# PLATTE SELF STORAGE

## GRADING AND EROSION CONTROL PLAN

### OVERVIEW SHEET

AUGUST 2024

**STORM SEWER MAIN RUN - PLAN & PROFILE**  
 HORZ SCALE: 1"=40' - VERT SCALE: 1"=4'

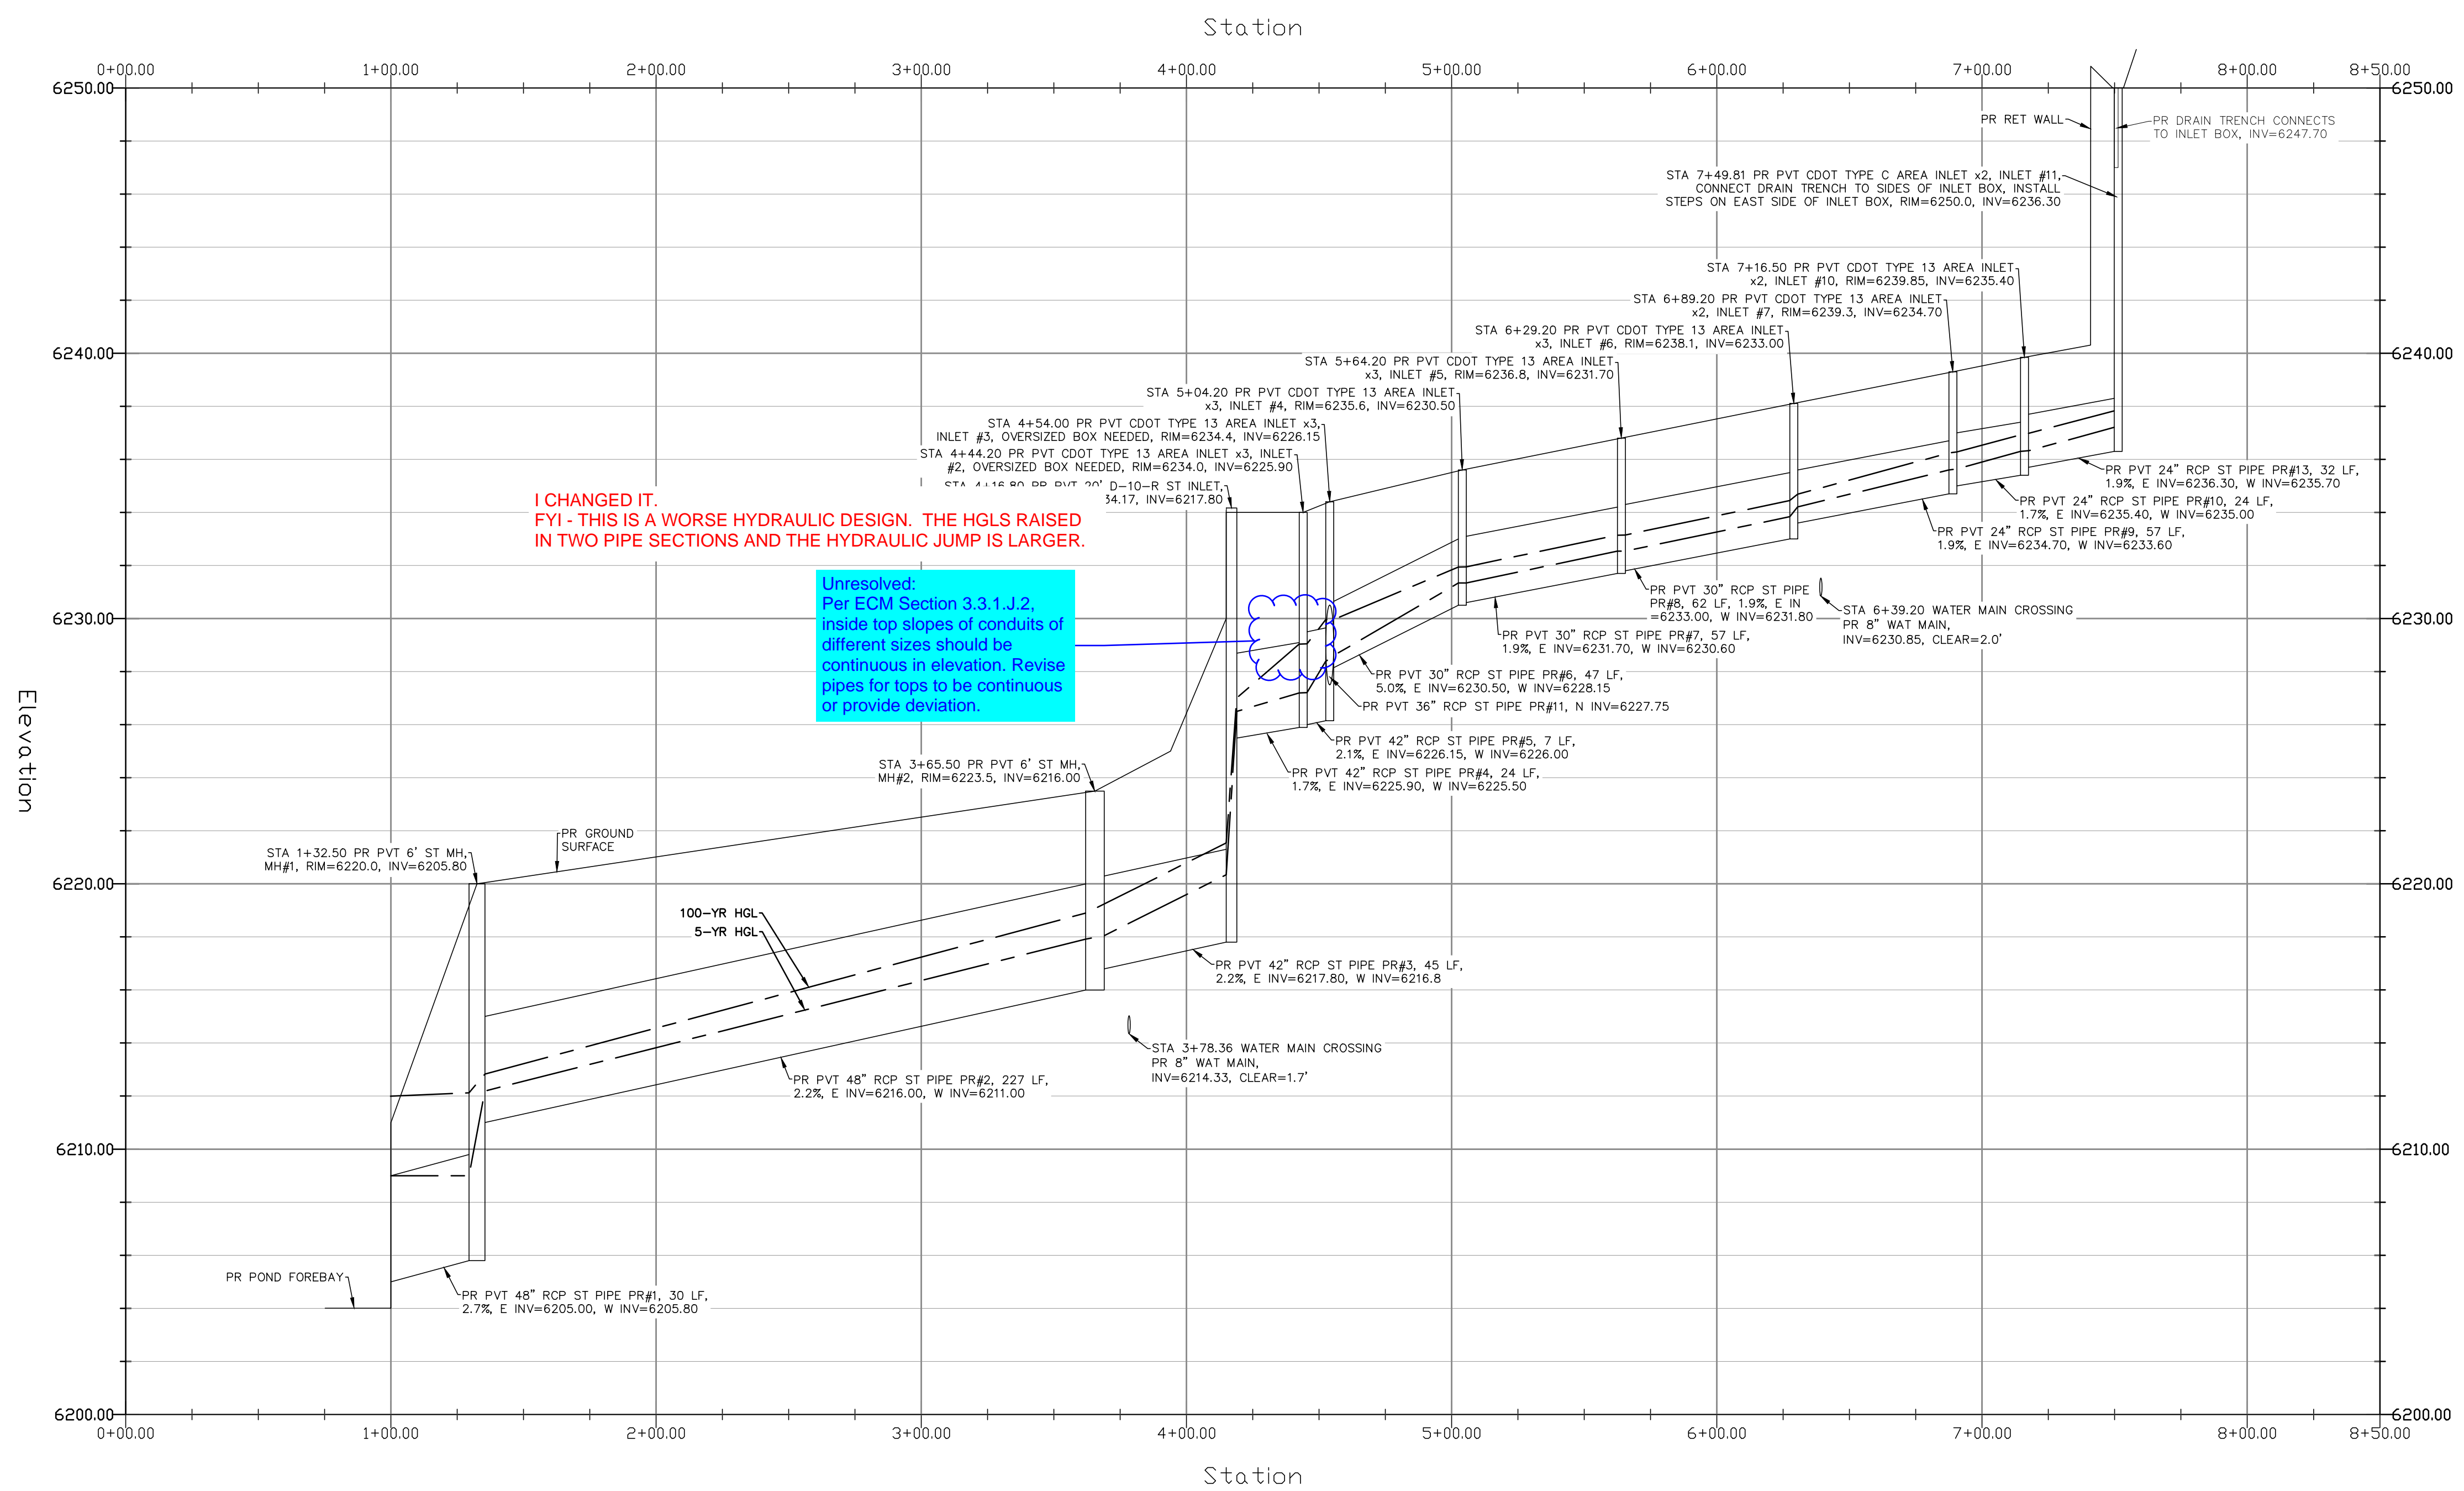
**Unresolved:**  
 Per ECM Section 3.3.1.J.2, inside top slopes of conduits of different sizes should be continuous in elevation. Revise pipes for tops to be continuous or provide deviation.

**I CHANGED IT. FYI - THIS IS A WORSE HYDRAULIC DESIGN. THE HGLS RAISED IN TWO PIPE SECTIONS AND THE HYDRAULIC JUMP IS LARGER.**

**OUTLET STRUCTURE**  
NOT TO SCALE

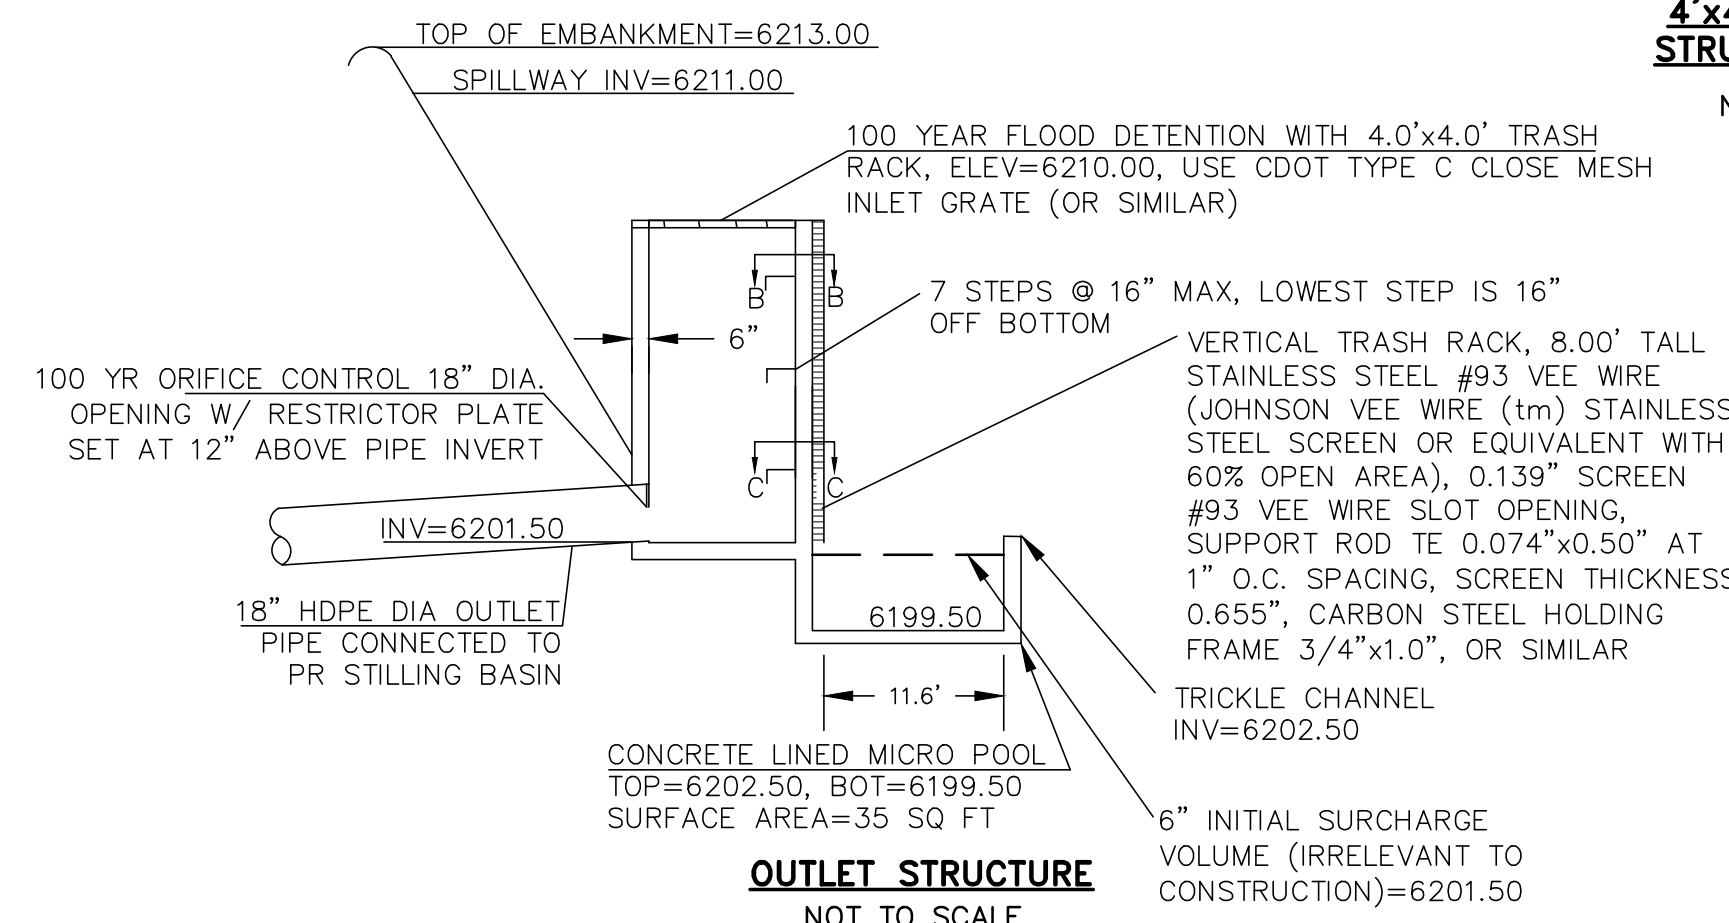
Unresolved from Submittal 1: This pond is deeper than 10-ft and likely qualifies as a state jurisdictional dam. At a minimum it would qualify as a non-jurisdictional water impoundment structure. Either submit jurisdictional or non-jurisdictional water impoundment structure application.

NON-JURISDICTIONAL WATER APPLICATION IS IN THE WORKS. WE'VE BEEN WAITING FOR OWNER INFO SINCE THE 1ST COMMENTS.

### EXTENDED DETENTION BASIN PLAN

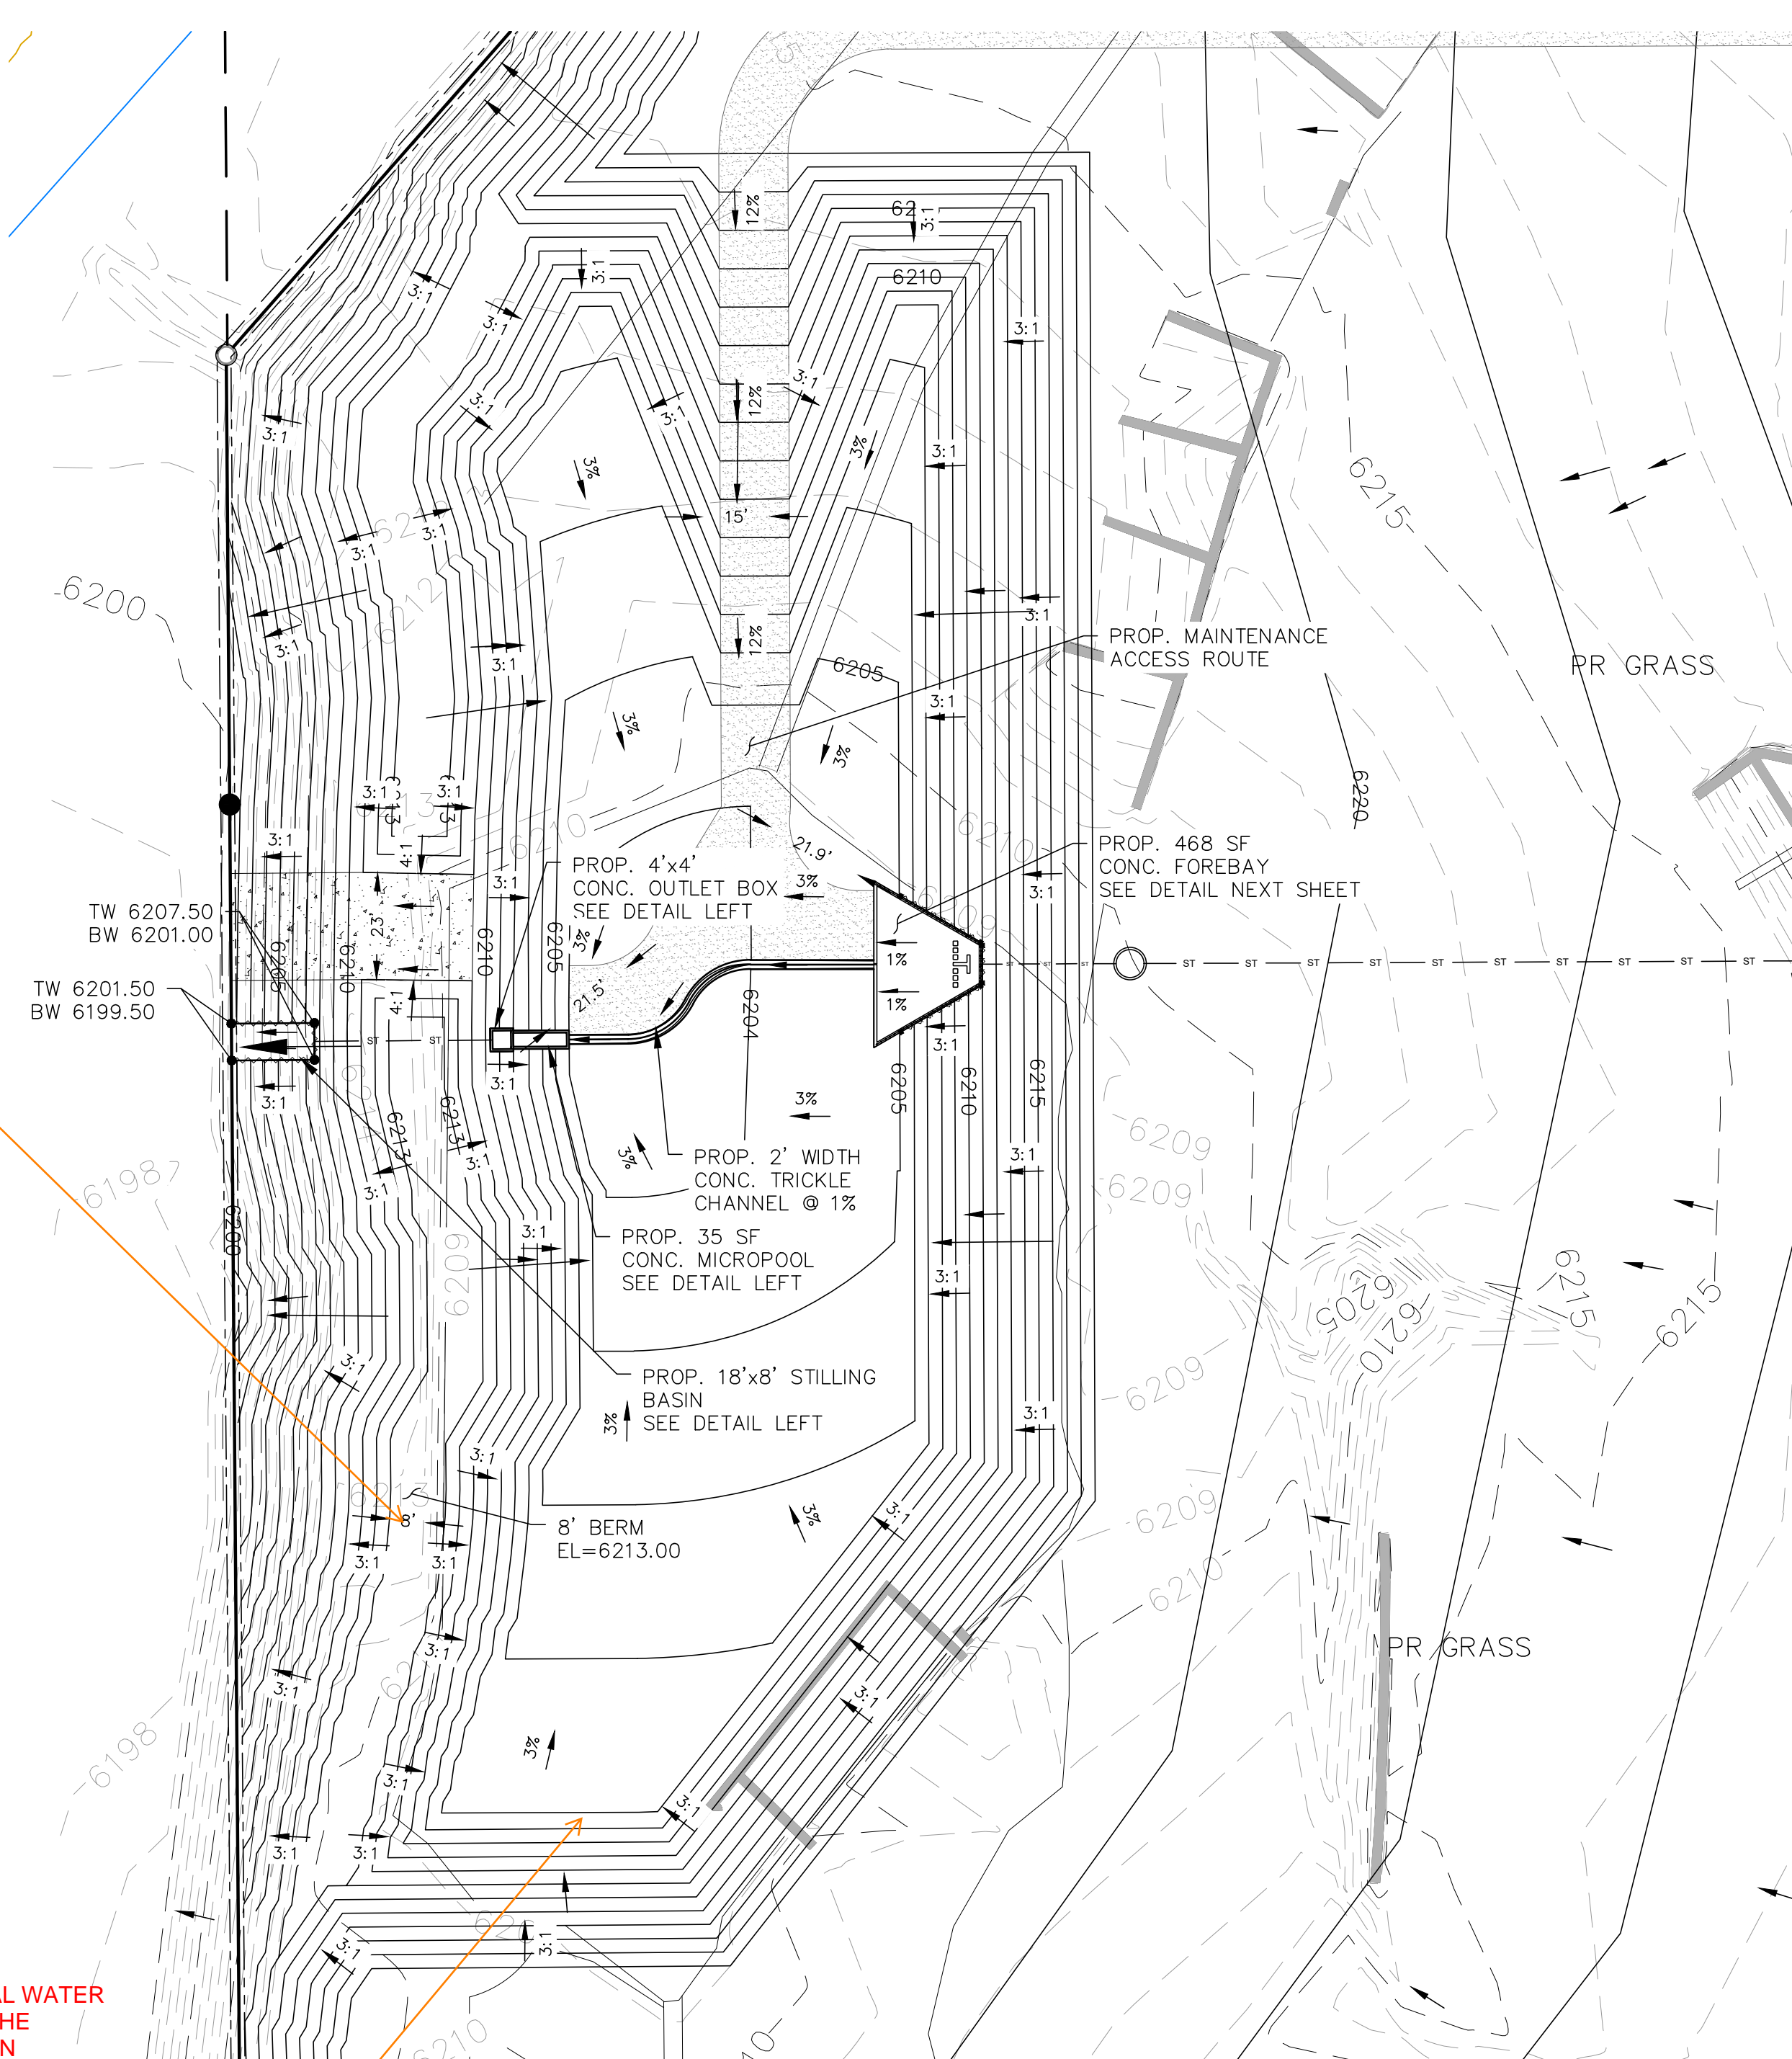
Unresolved: Per DCMV1 Chap 11.3.3, adjust pond design to include a min. width of 12ft at top of embankment.
